***SR9 WIDENING AND RECONSTRUCTION  
FROM SR 141 TO SR 20  
STP-1336(11), P.I. No. 121690  
Forsyth County, Georgia***

**Value Engineering Study Report  
Concept Submittal**

**re: SR 9 Widening from SR 141 to SR 20  
Project No. STP-1336(11), P.I. No. 121690  
Value Engineering Study Report**

**ALTERNATIVE S-2 - TYPICAL SECTION**  
(w/Multi-Use Path)

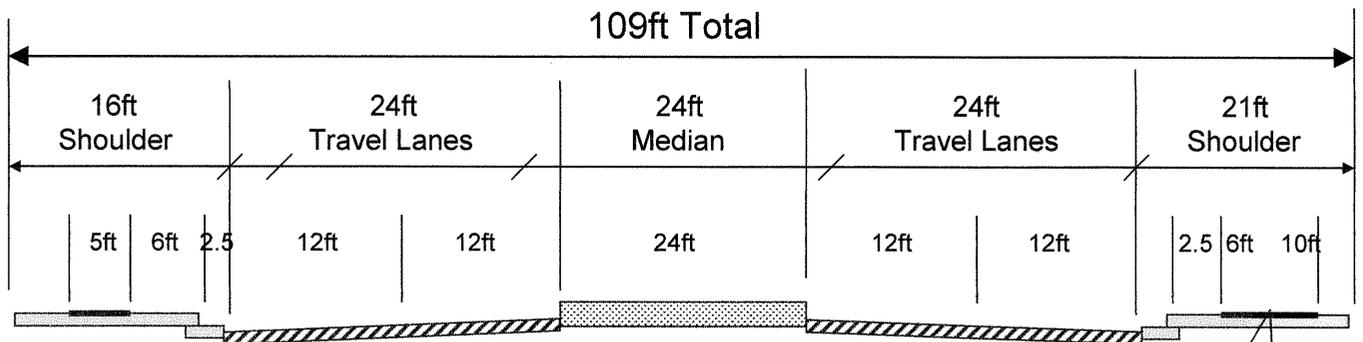
Provide a 10-ft. multi-use trail on one shoulder in lieu of using two 4-ft. bike lanes.

The 10-ft. multi-use trail would replace the two 4-ft. bike lanes, requiring less additional R/W and reducing the pavement section (7.5 in. vs. 2 in.) of asphalt concrete.

ALTERNATIVE S-3 - TYPICAL SECTION  
 (11ft lanes w/10ft wide Multi-Use Path)

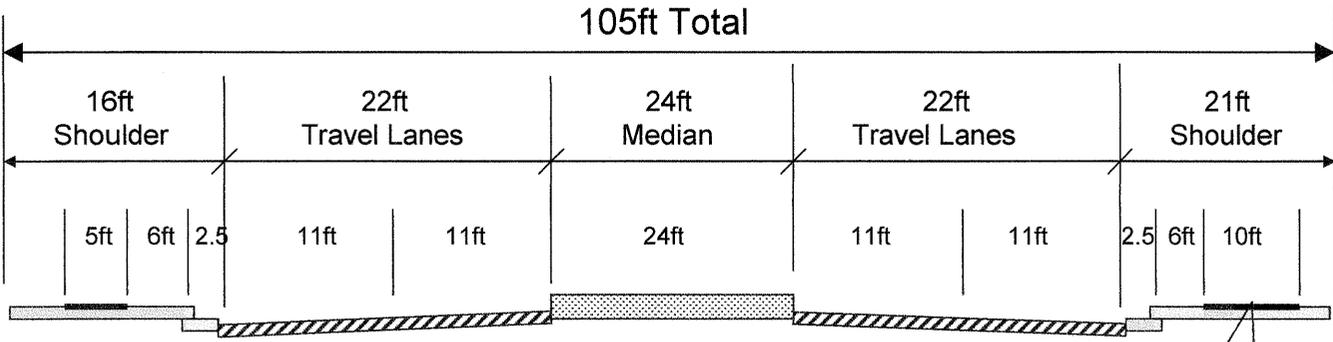
Provide four 11-ft. travel lanes with a 10-ft. multi-use trail in lieu of two 4-ft. wide bike lanes.

**ALTERNATIVE S-4**  
 (w/8ft Wide Sidewalks)

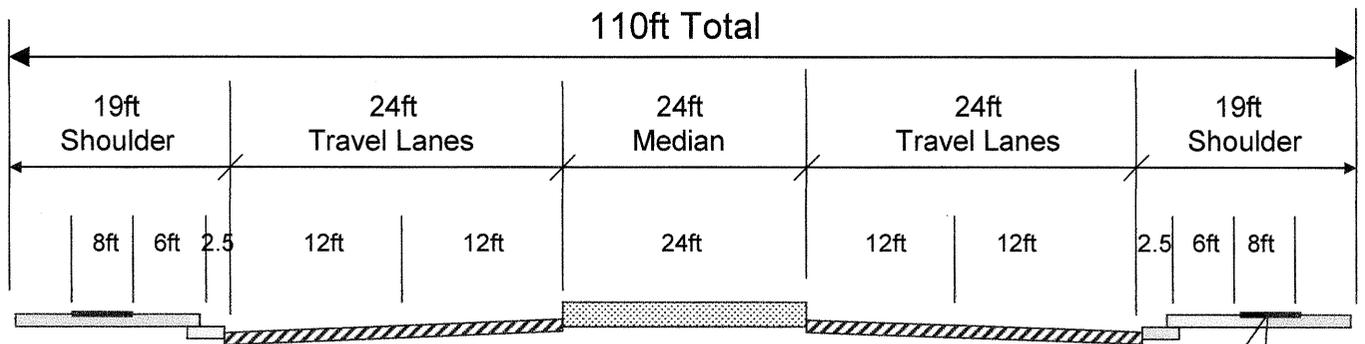
5' sidewalk vs. 8' sidewalk  
(10' total) (16' total)  
extra: sidewalk  $\frac{6' \times 3 \text{ mi} \times 5,280' / \text{mi}}{9} = 10,560 \text{ SF}$

**AS-DESIGNED TYPICAL SECTION**  
 (w/Bike Lane)

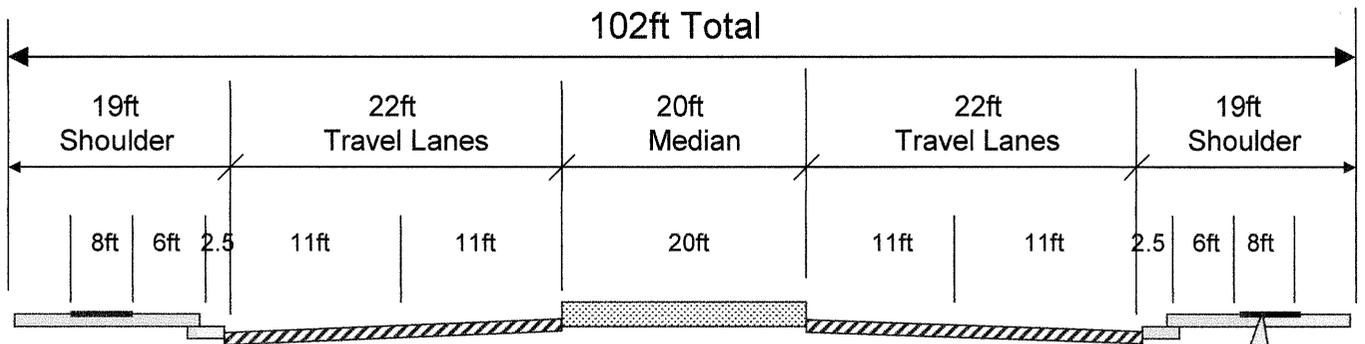
This saves costs by utilizing 11-ft. lanes and a 20-ft. median, which has been done previously. Also utilizes two 8-ft. trails for pedestrians and bikes.

**AS-DESIGNED TYPICAL SECTION**  
 (w/Bike Lane)

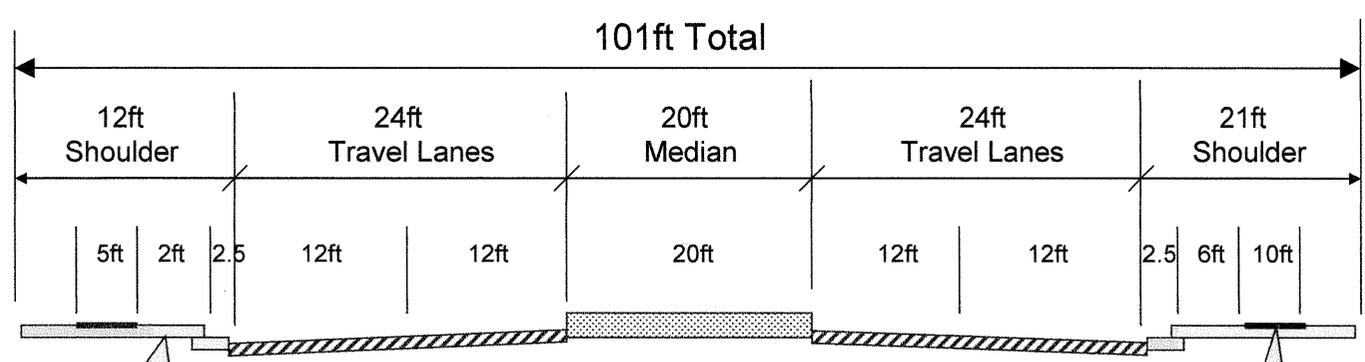
This typical section would reduce the project cost by reducing the R/W cost enough to “pay” for the multi-use trail.

**VE ALTERNATIVE S-7**  
 (w/11ft Lanes, 20ft Median, 5ft Sidewalk,  
 10ft Multi-Use Trail)

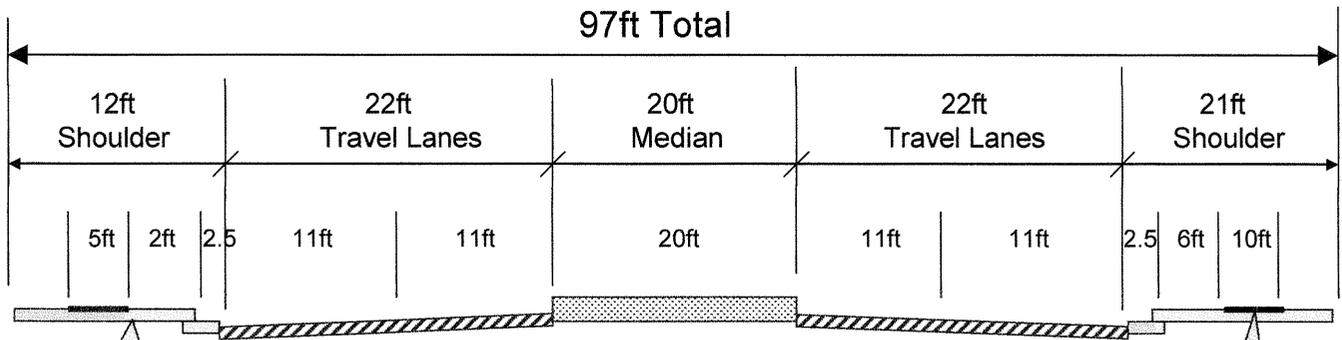
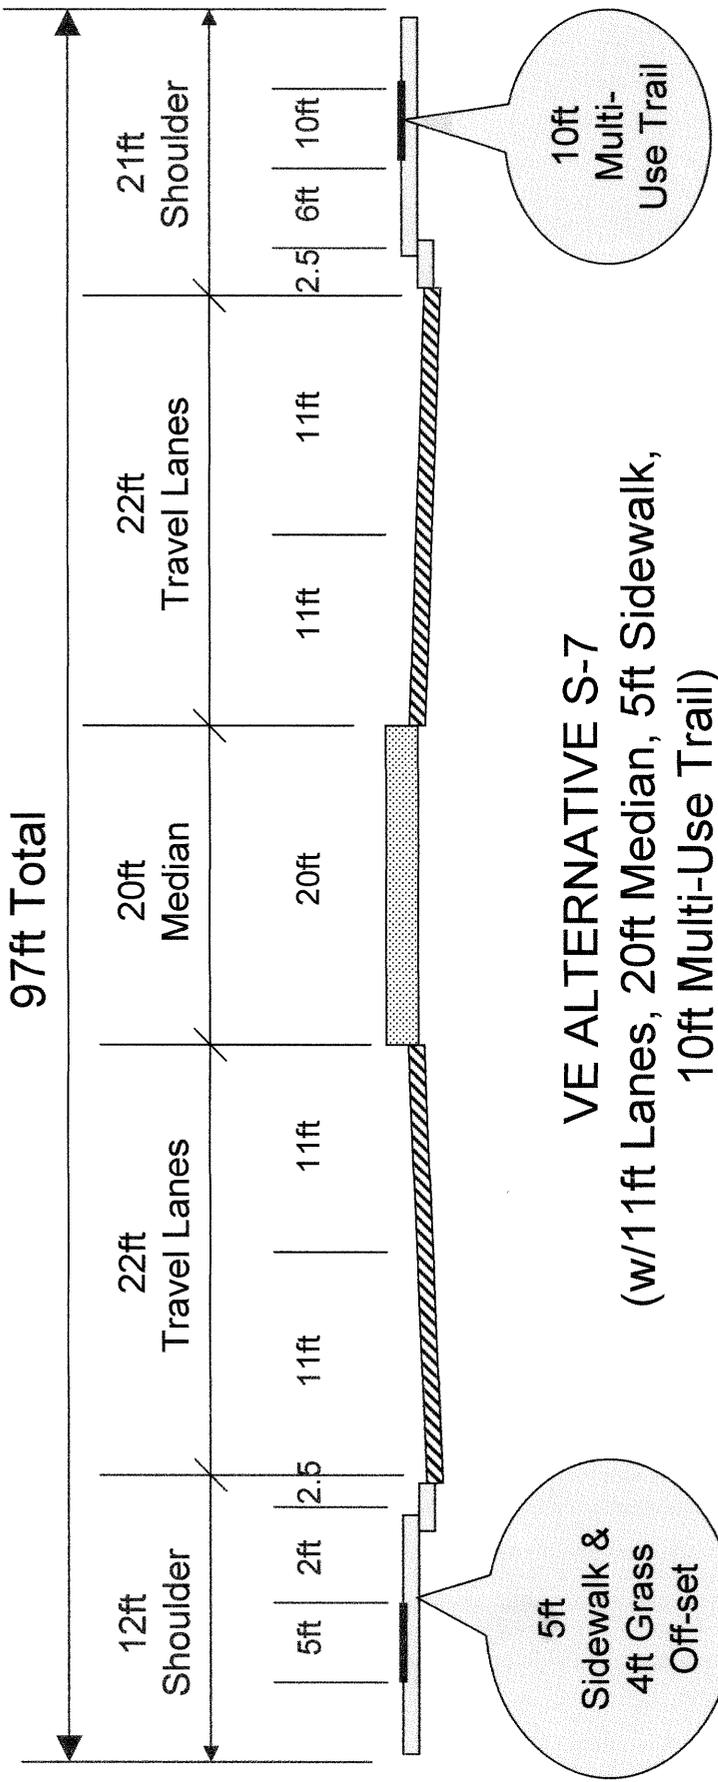
This has the greatest savings due to reducing the full depth pavement by 12 ft. (two 4-ft. bike lanes) and using four 11-ft. traffic lanes.

VE ALTERNATIVE S-8  
 (Rural Section to provide R/W for 6-lane Urban Section)

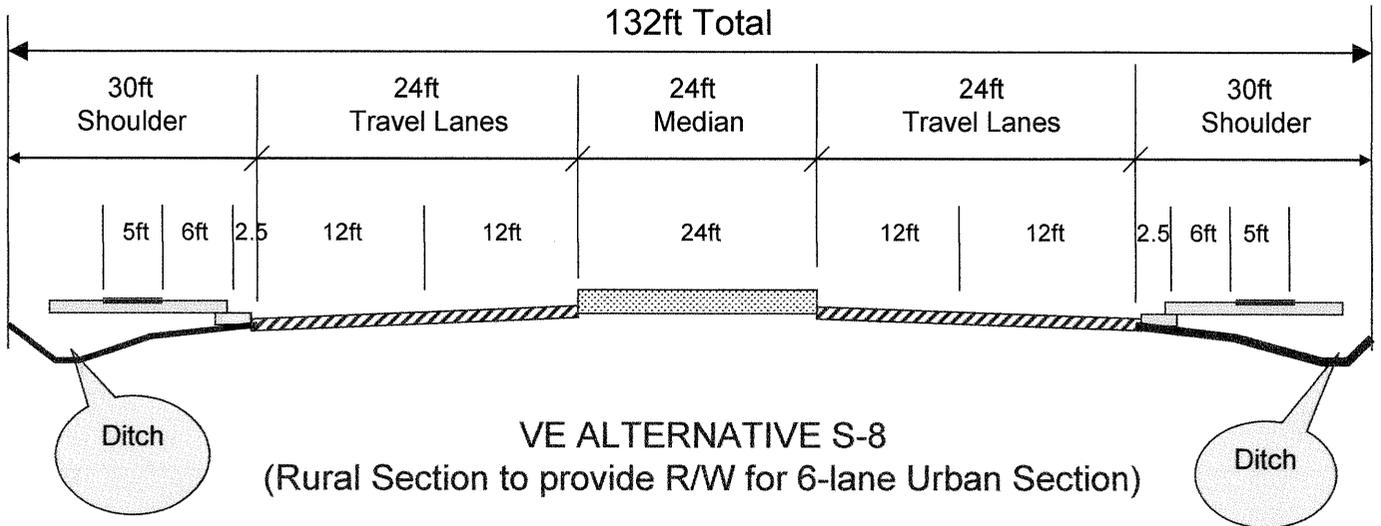
The original typical section proposes a four-lane urban section with a 24-ft. median and 16-ft. shoulders with a 104-ft. R/W. If two 4-ft. bike lanes are added, the R/W would be 112 ft.

This proposes a rural four-lane section with a ditch. The extra R/W for the ditch would provide enough R/W for a future six-lane project with urban designers.

VE ALTERNATIVE S-9  
(Depressed Median)

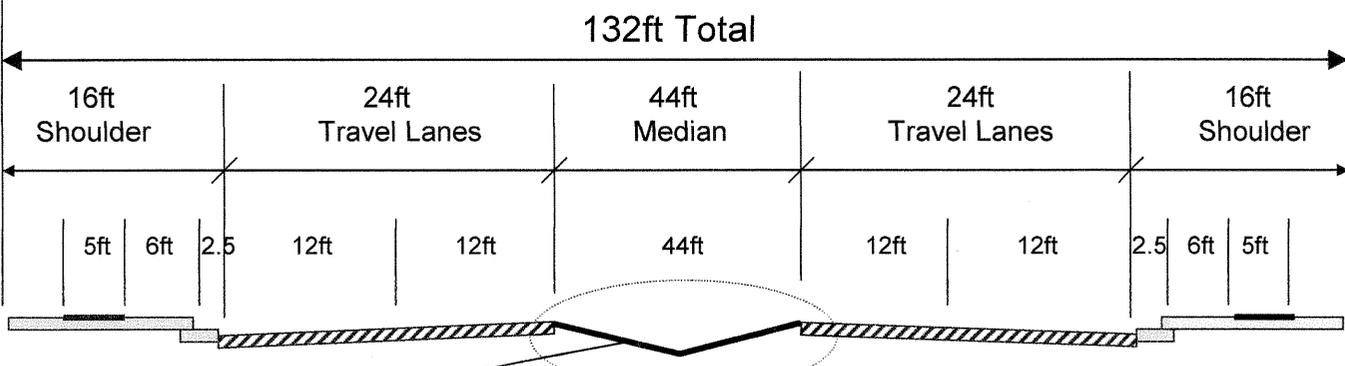
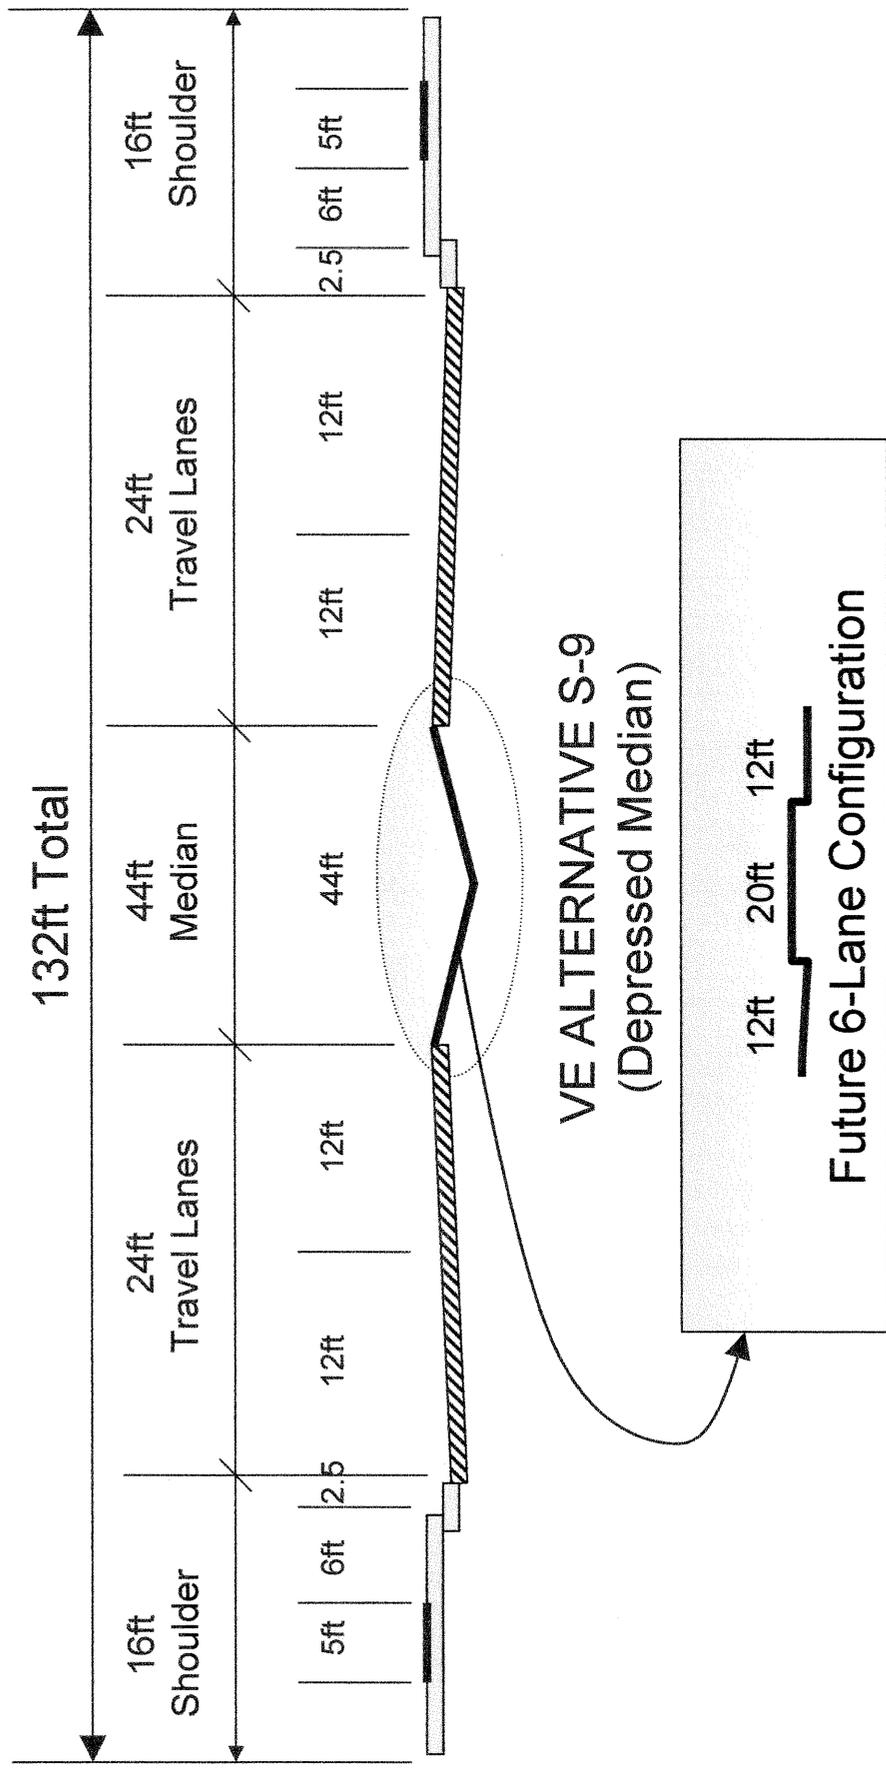
The original typical section proposes a four-lane urban section with a 24-ft. median and 16-ft. shoulders with a 104-ft. R/W. If two 4-ft. bike lanes are added, the R/W would be 112 ft.

This proposes to build a four-lane urban section (on the outside) with curb and gutter and have a 44-ft. depressed grass median for extra width to expand the road to six lanes with a 20-ft. median in the future. The extra R/W for the ditch would provide enough R/W for a future six-lane project with urban designers.

**VE ALTERNATIVE S-11**

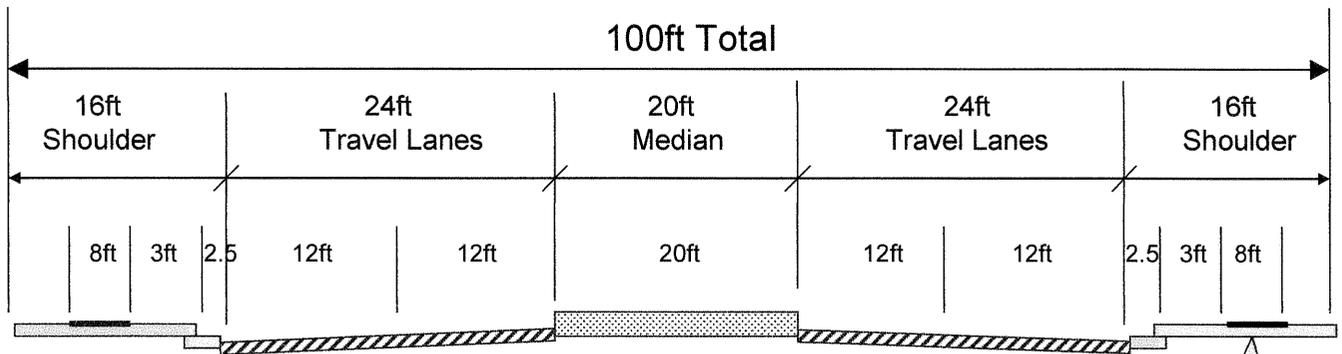
This would reduce the proposed 24 ft. median to 16 ft., which would meet the required R/W by 8 ft. This could be a substantial cost saving since the R/W is the most expensive item for the project.

**VE ALTERNATIVE S-12**  
(w/8ft wide Multi-Use Path)

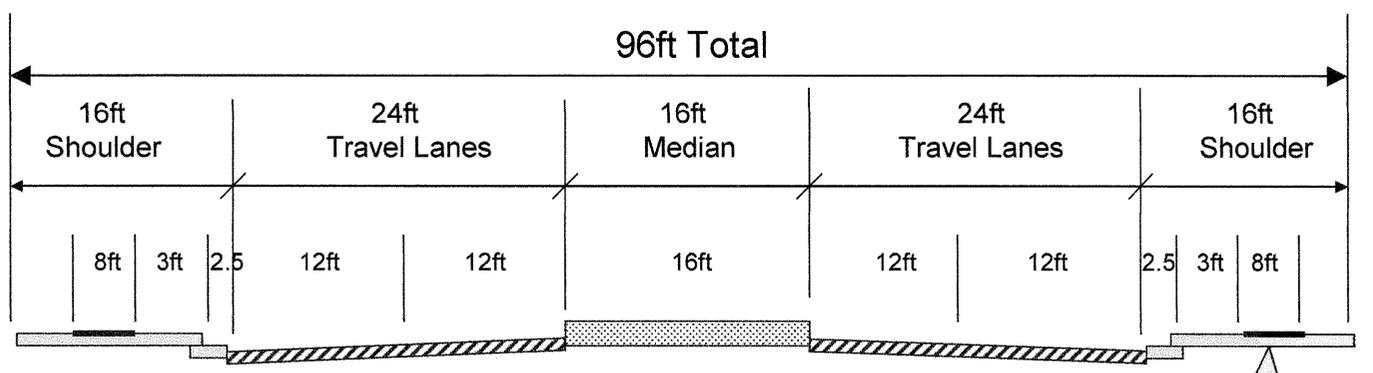
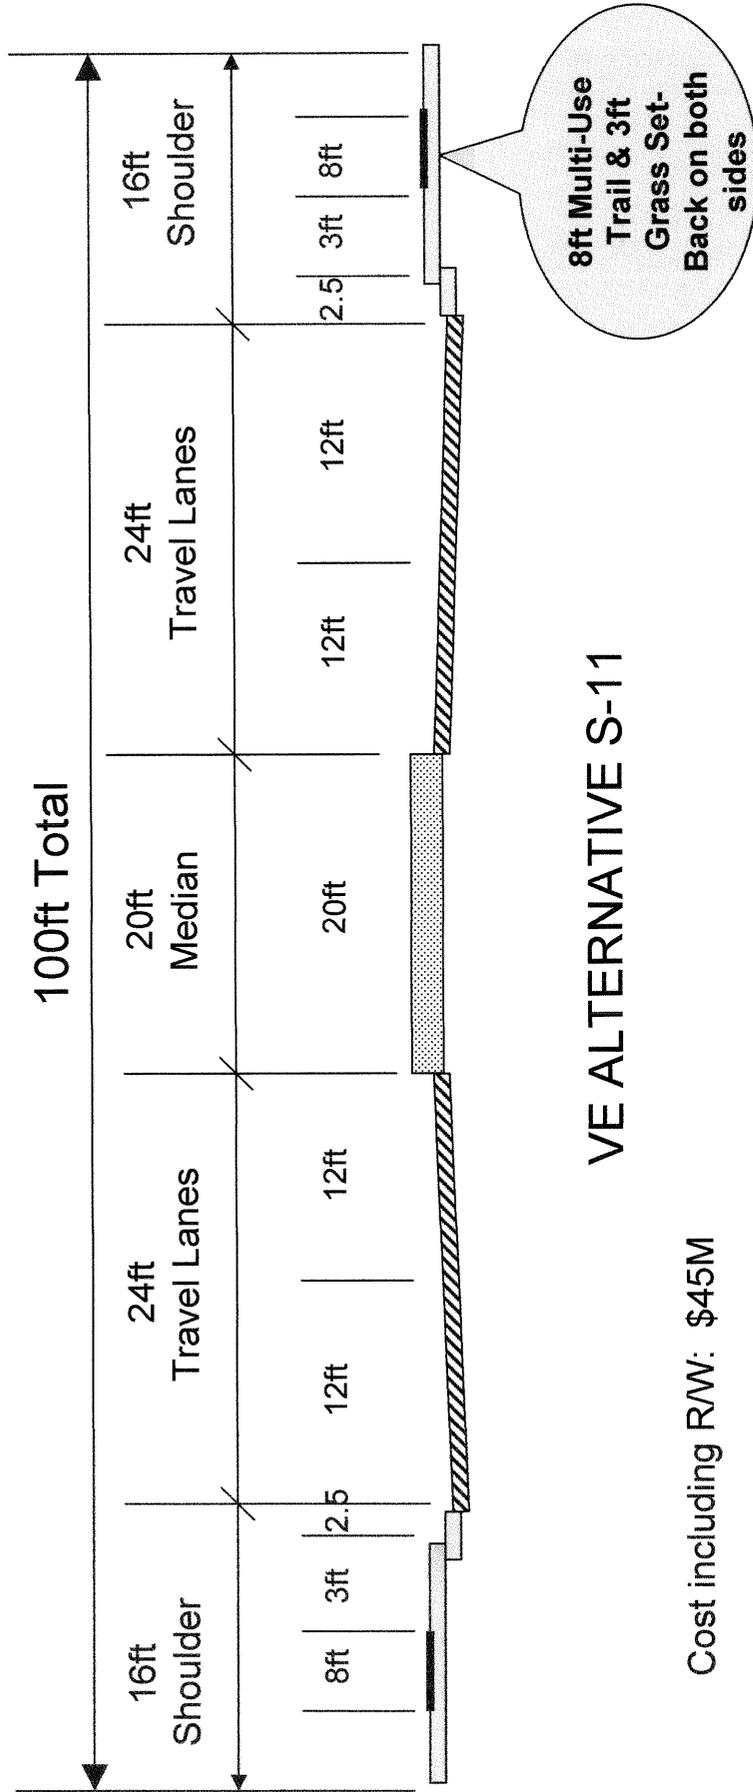
This alternative offers an optimum combination of median and multi-use paths while minimizing the R/W, providing bike paths on both sides of the street.
